Memorandum to the City of Markham Committee of Adjustment

File: A/52/18
Address: 179 Bay Thorn Drive, Thornhill
Applicant: Massoud Ghahremani
Agent: Georgio Lolos Designs (Georgio Lolos)
Hearing Date: Wednesday June 13, 2018

Re: **Variance Application - A/52/18 – Recirculation**
179 Bay Thorn Drive, Markham, ON
Massoud Ghahremani (Owner)
Georgio Lolos Designs (Agent: Georgio Lolos)

LEFT SIDE ELEVATION

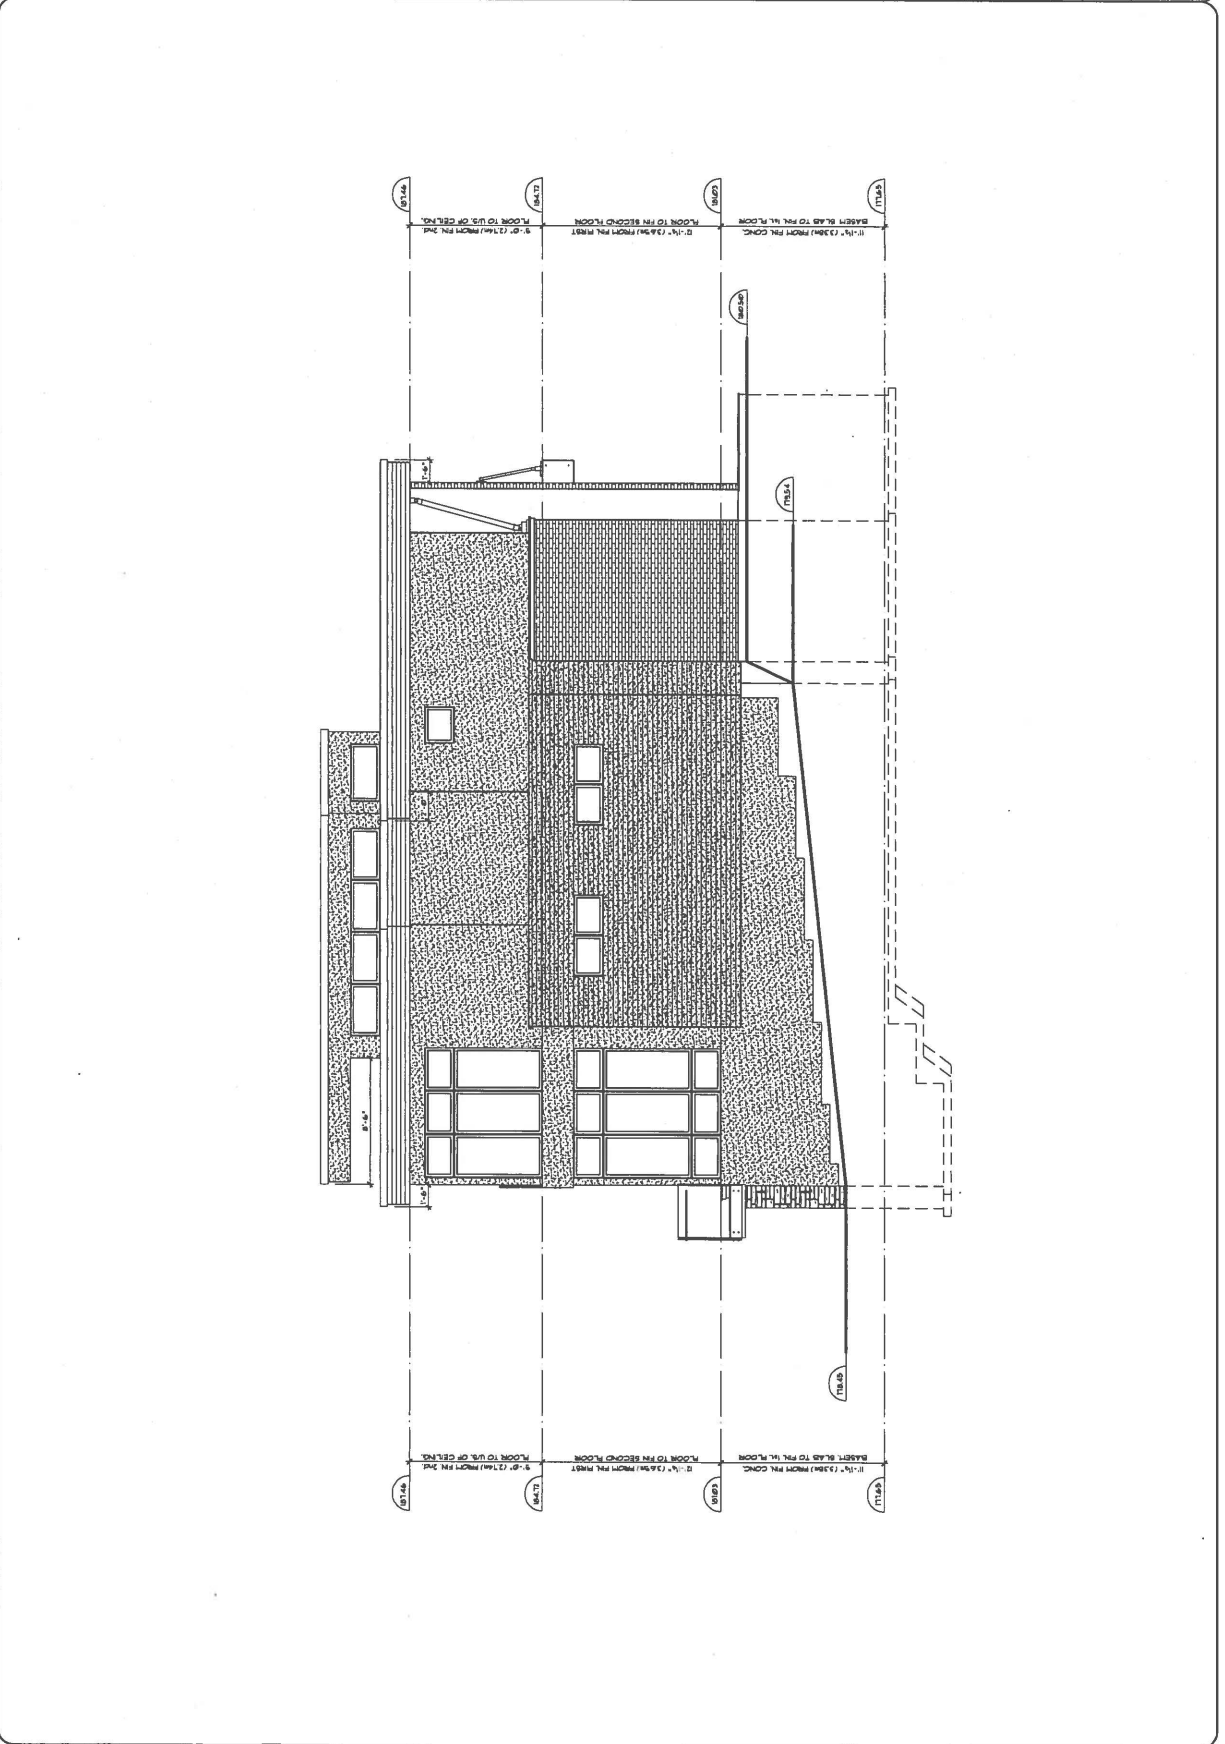
The applicant is requesting a minimum south side yard setback of 4 ft (1.21 m) for the two-storey portion of the dwelling, whereas the by-law requires a minimum side yard setback of 6 ft (1.82 m). This represents a reduction of 2 ft (0.6 m) or 33.33 percent from the by-law requirement. The variance only applies to a cantilever on the second floor which includes a small area of the washroom in Bedroom #2 (See Appendix B).
